SUBJECT: Forwards revised FSAR Section 7.7 clarifying Scram discharge high level vol & computer sys block diagram. Revs will be incorporated in next FSAR amend.

SUSQUEHANNA STEAM ELECTRIC STATION  
FSAR SECTION 7.7  
ER 100450 FILE 841-1  
PLA-1837

Docket No. 50-388

FIGURE 7.7-13

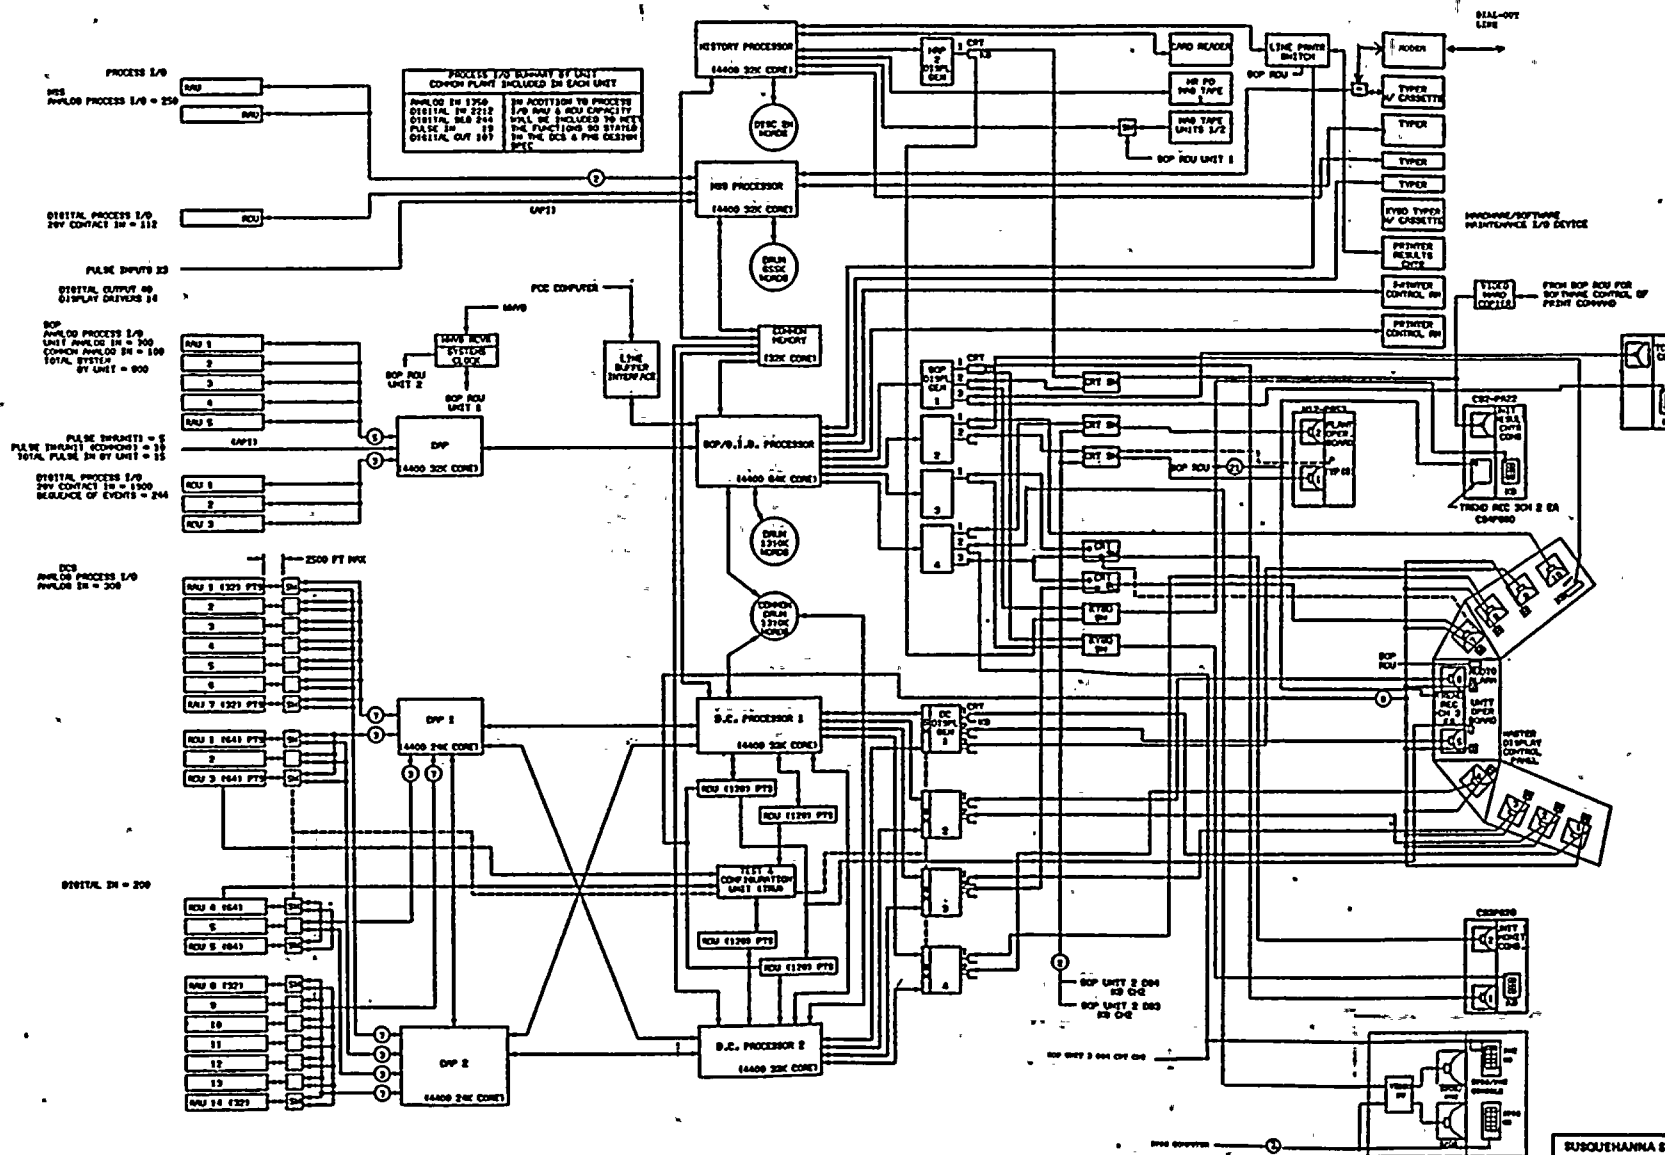
Fig. 7.7-13 - This figure has been revised to show the location of the SPDS CRT's.
